Re: Florida Power & Light Company  
Proposed Turkey Point Units 6 and 7  
Docket Nos. 52-040 and 52-041  
Response to NRC Request for Additional Information Letter No. 046 (eRAI 6077)  
Standard Review Plan Section 02.01.03 - Population Distribution

Proposed Turkey Point Units 6 and 7  
Docket Nos. 52-040 and 52-041  
FPL Response to NRC RAI No. 02.01.03-1 (eRAI 6077)  
L-2012-011 Attachment Page 1 of 10

**NRC RAI Number: 02.01.03-1 (eRAI 6077)**

Figure 2.1-207 10-Mile 2000 Resident and Transient Population Distribution

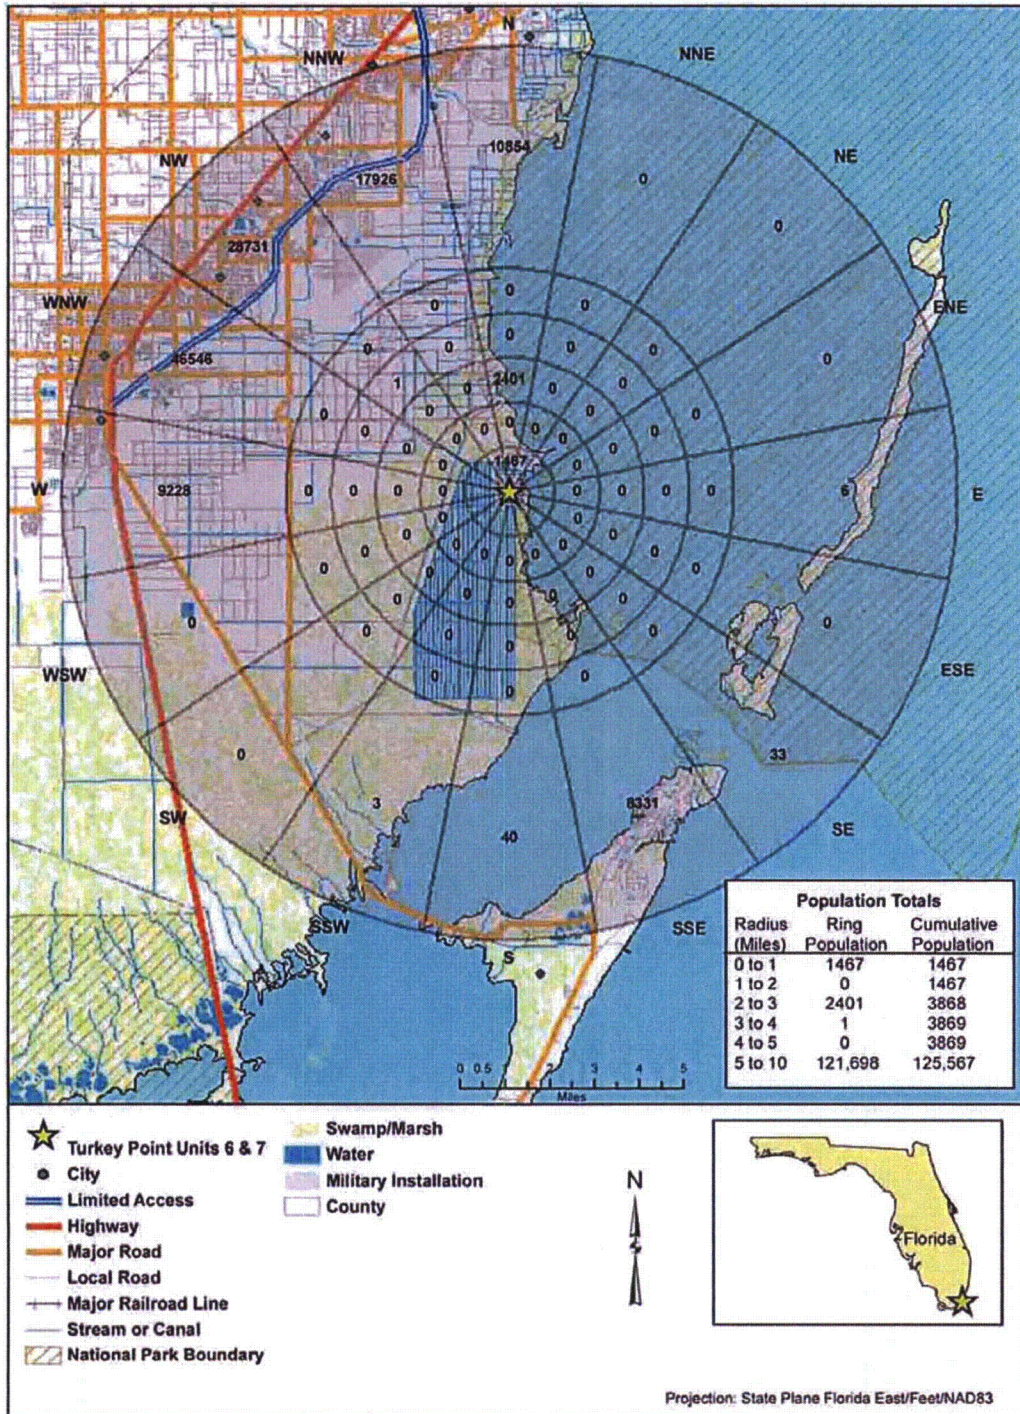
Pursuant to 10 CFR 52.79(a)(1)(v), a final safety analysis report (FSAR) shall include the existing and projected future population profile of the area surrounding the site. Sections 2.1.3.1, 2.1.3.3.1 and 2.1.3.4 state that the population maps in Figures 2.1-107 through 2.1-215b include both resident and transient population distributions. However, only Figure 2.1-209 is labeled "10-Mile 2020 Resident and Transient Population Distribution." All other figures in this series are labeled "10-Mile 20[ ]0 Population Distribution." Clarify the titles of figures showing 10-mile population data in Section 2.1.3 of the FSAR

Figures 2.1-207 through 2.1-215b (excluding Figure 2.1-209) will be renamed to indicate the inclusion of both resident and transient populations.

Figures 2.1-207, 2.1-208 and Figures 2.1-210 through 2.1-215b will be revised as follows in a future revision to the COLA.
